Addendum No. 4

Architectural and Mechanical Energy Upgrades at Pine Street School – Phase 4 McMillan Pazdan Smith Project No. 018441 December 5, 2019

1
 AD-4.1

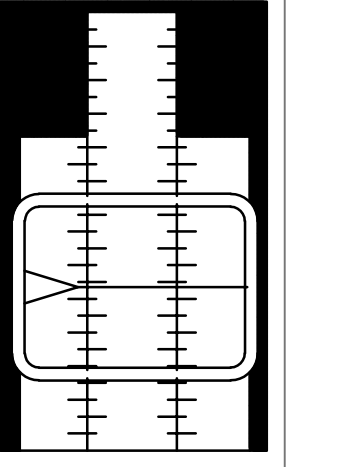
Item No. 5: **Architectural Drawings – Sheet A3.11 – Ground Floor RCP Area – Detail A1/A3.11 Ground Floor RCP:**

Include the attached drawing AD4.1 into the contract documents.

NOTE:
 TYPICAL AT ALL 1ST GRADE CLASSROOMS STORAGE AREAS G.C. SHALL REMOVE THE EXISTING CEILING AS REQUIRED TO INSTALL MECHANICAL DUCT PER THE MECHANICAL DWG'S. INSTALL NEW ACOUSTICAL CEILING TILE AND GRID AFTER INSTALLATION OF DUCTWORK.

SECTION THRU PIPE TRENCH
NO SCALE

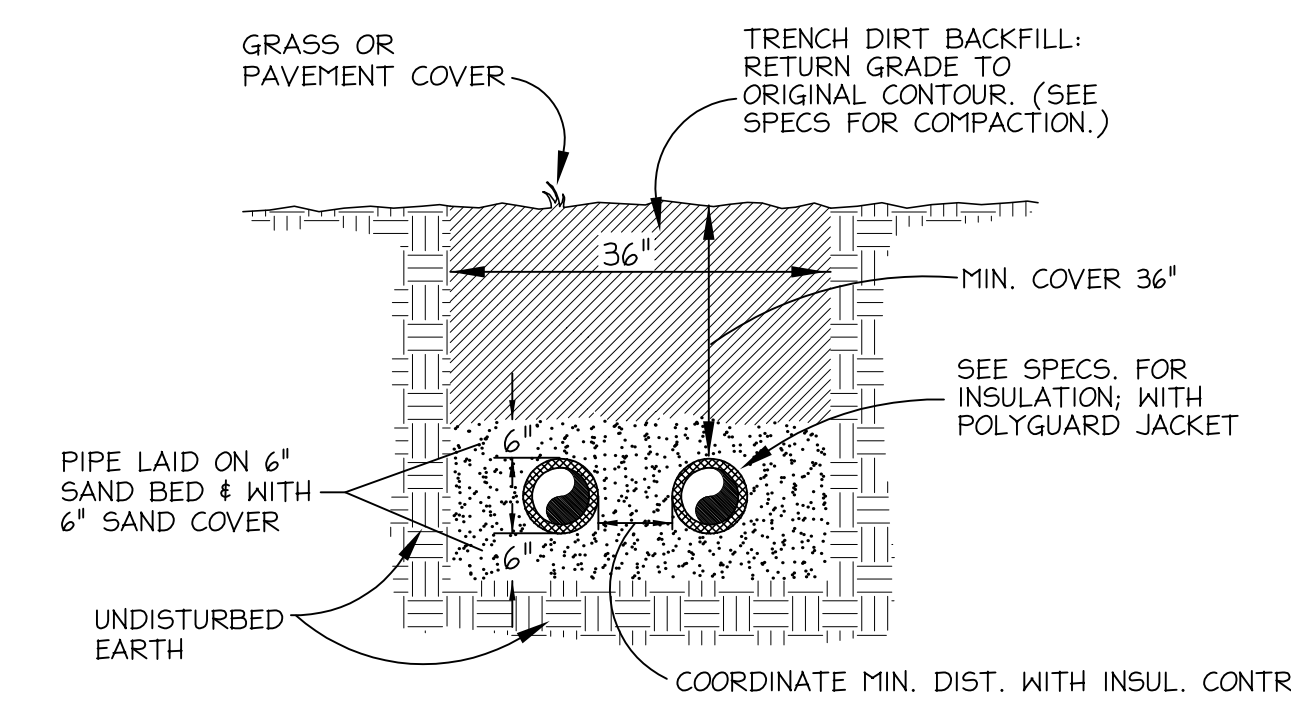
- 1. At the contractor's option, pipe headers may be installed full size, without reducers.
 - 2. All piping shall be bedded in an 18" deep clean sand bed. See detail on drawings.
